Hartland Township Planning Commission Meeting Agenda Memorandum

Subject: Site Plan/PD Application #24-001 Highland Road Self-Storage Facility PD – Preliminary Planned Development Site Plan

Preliminary PD Site Plan Review

Re: Proposed Self-Storage Facility – Preliminary PD Site Plan Review #4
SDA Review No. HL22-122

A 400

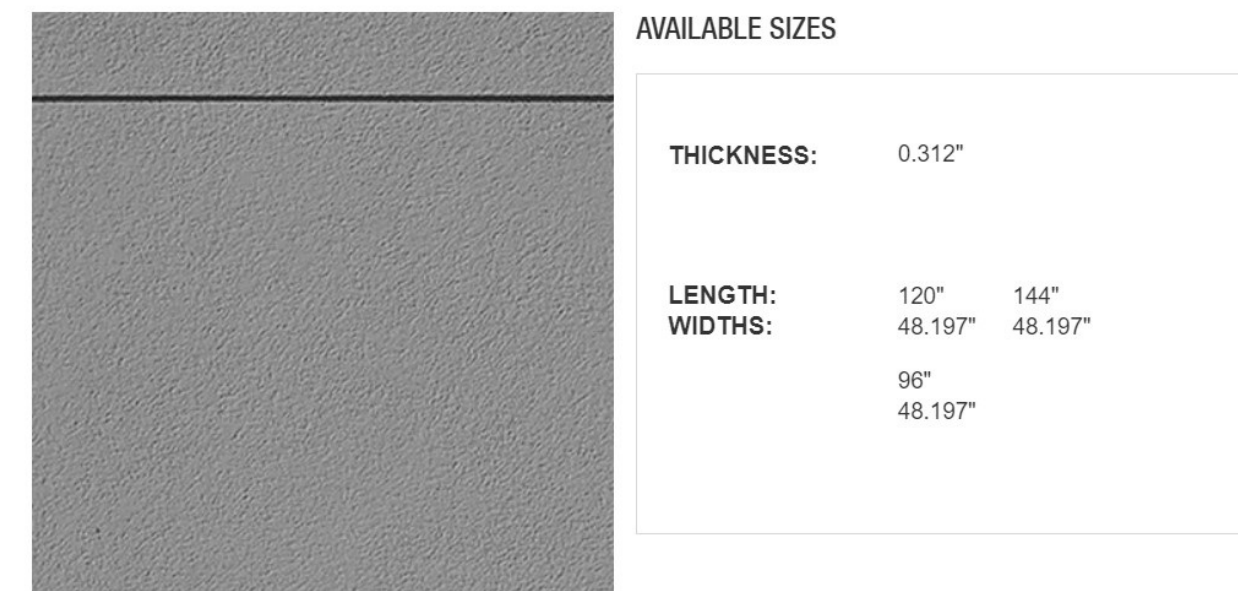
- Façade Materials Calculation – façade materials must comply with the specifications for Façade Materials Group #1; percentages for each elevation are provided on Sheet A400 of the Architectural plans.

- Colors: Color renderings of the building are provided. Specific product information for each façade material is stated on Sheet A400. Earthtone colors are proposed for all products. Metal awnings are blue.
- Materials: Percentages are listed for each elevation side as indicated by the table; specifications on all materials are provided.
- Meets Requirement? – **TBD**
- Comment – Masonry A product is described as 8” by 16” split faced block with raked horizontal joints and stained with a Sherwin Williams product (stain color is Black Bean). Planning Commission to determine if the façade material Masonry A (stained and scored block) is acceptable.

DRAWING:
C-4

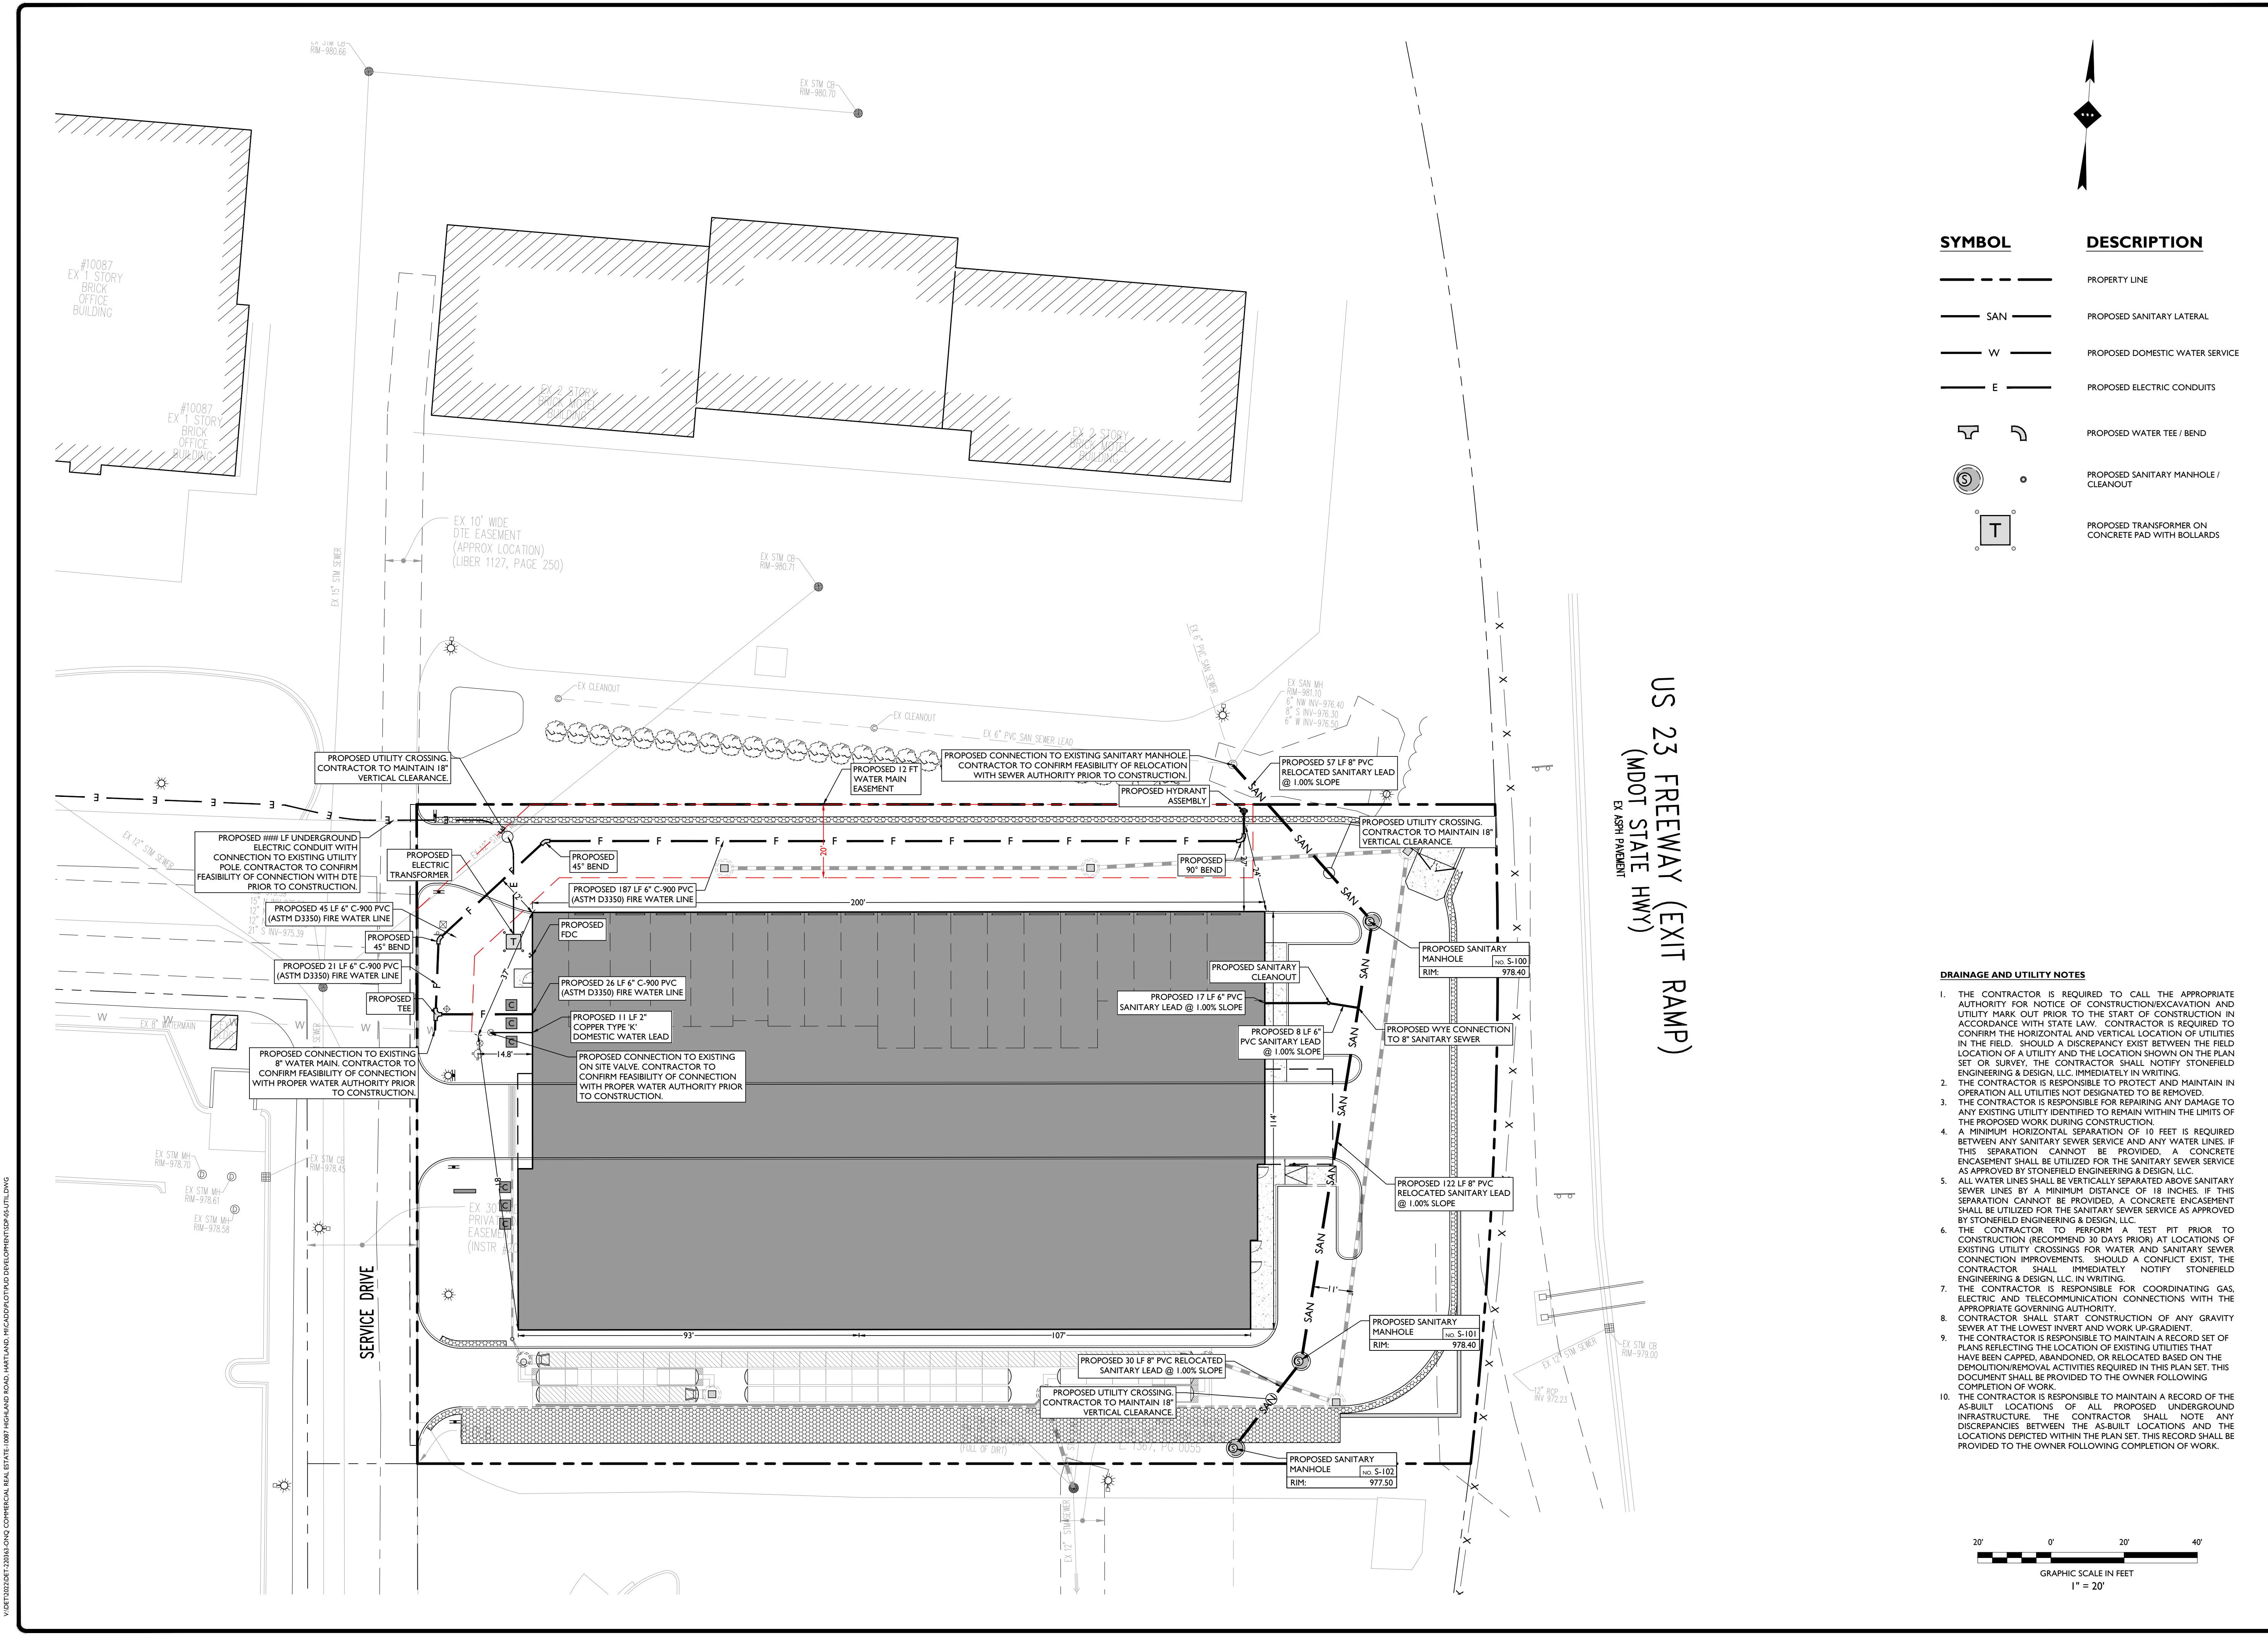
The stormwater management plans show an underground chamber system on the south side of the building, under the drive aisle. Details are shown on Sheet C-4 and Sheet C-12.

2. Drawing C-4: See Current Design and Engineering Standards, many items will require addressing via the link (<https://www.hartlandtwp.com/planning/page/hartland-township-design-and-engineering-standards>)

3. Drawing C-4: Callouts on 12" RCP show slope pipes having slope of 0.30%, however inverts calculate a slope of 0.48%. Revise slope in callouts.
4. Drawing C-4: Use correct class of storm sewer for shallow cover.

TITLE: **UTILITY PLAN**

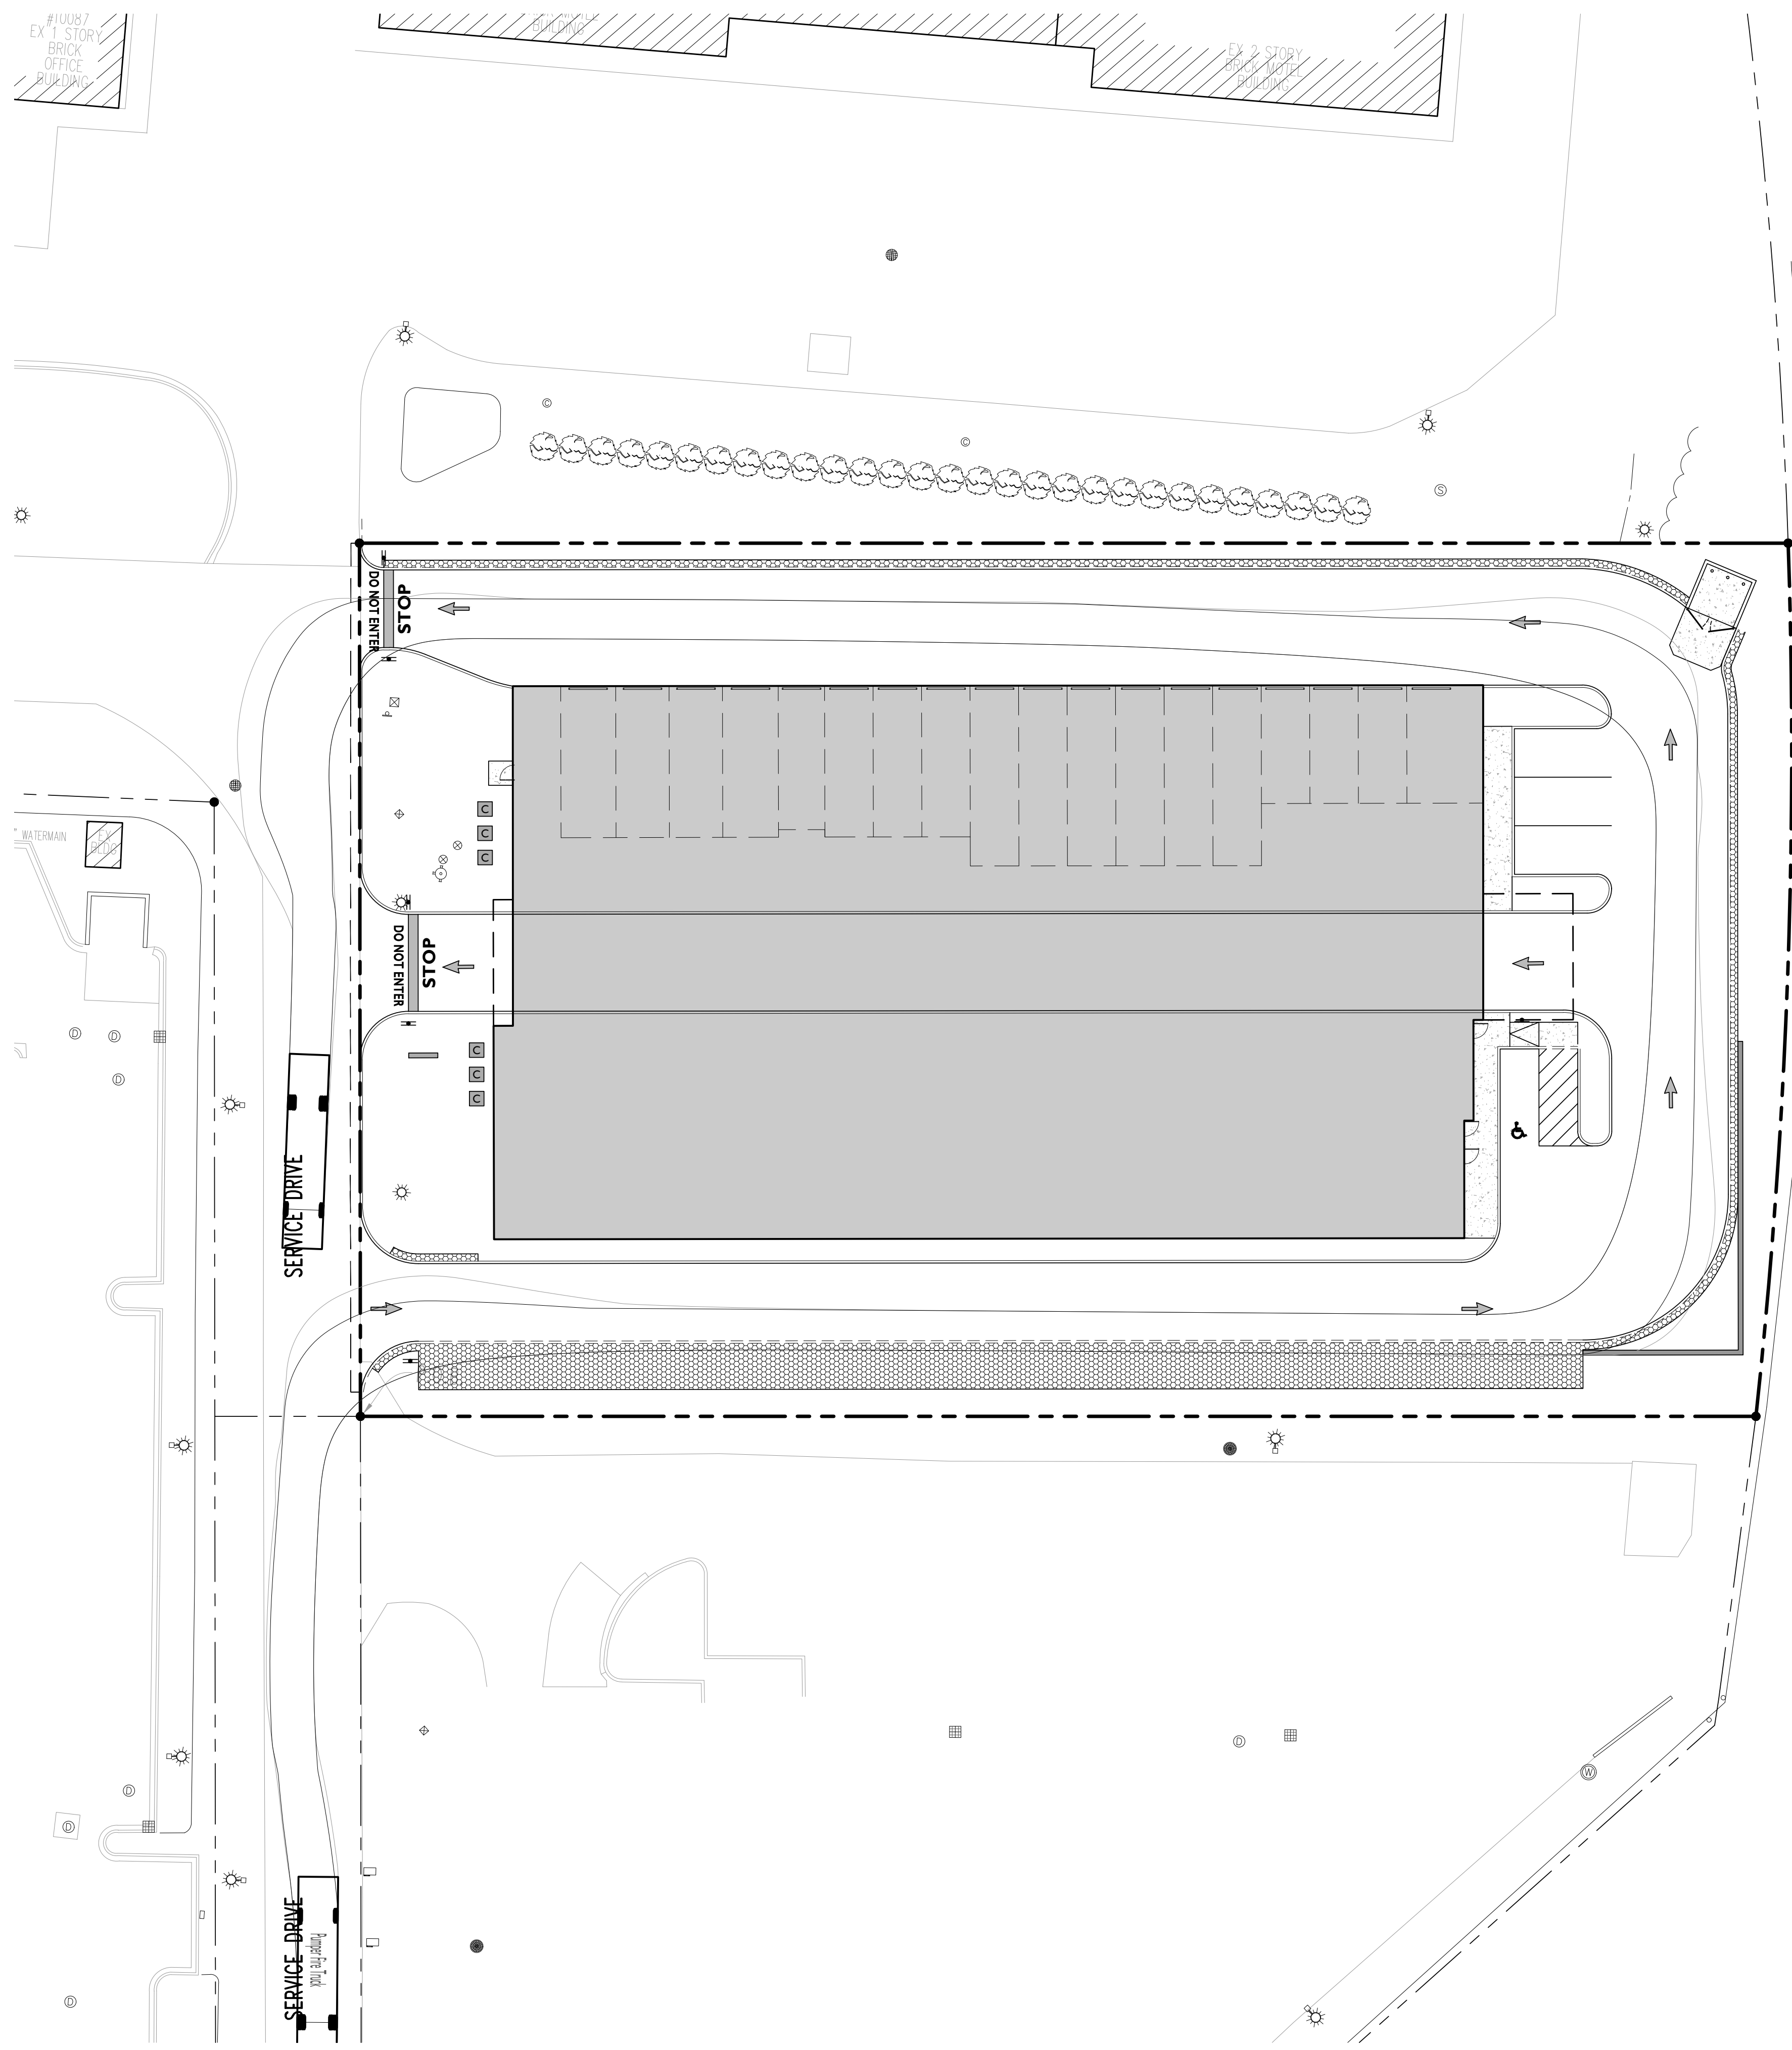
1. Drawing C-5: Water main 20 foot wide easement is shown correctly, revise callout from Proposed 12 FT to Proposed 20 FT.
2. Drawing C-5: 8” water main shall be used from connection to existing water main to proposed hydrant.

1. Drawing C-5: All storm sewers must be located in a public right-of way or an easement. The minimum storm sewer easement shall be 12 feet wide. The easement size will vary as required for maintenance and access. Any storm sewer that accepts runoff from abutting property or public right-of-way must be placed in a minimum 12 foot storm sewer easement.
